# Access Compliance Report

## Public Rights-of-Way

Intersection ID: 48570	Main Street: MATLEA_CT	Cross Street: RED_SQUIRREL_TL	Location: SW
ADA ID: A5520E936033	Ramp Type: Perp	Initial Pass/Fail: Fail	Overall Compliance: No
Severity Score: 13.75			
Codes/Mitigation Info/Possible Solution		Field Measurements/Component Compliance

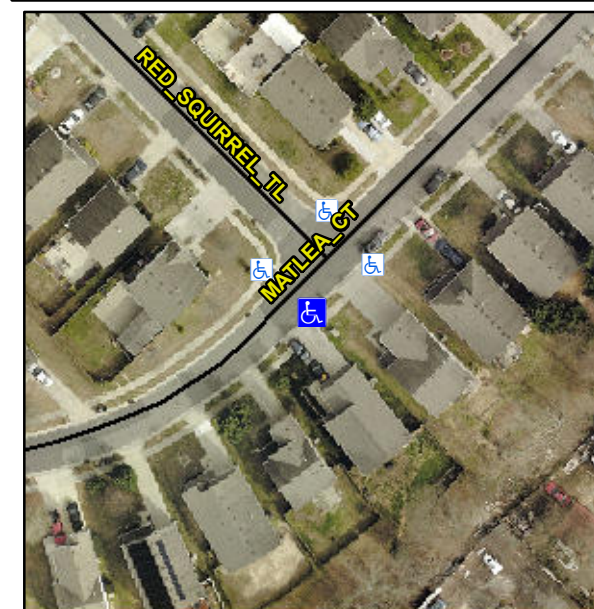
**Remove & Replace Entire Ramp.**

**Not Found, R304.2.2, R304.5.3**
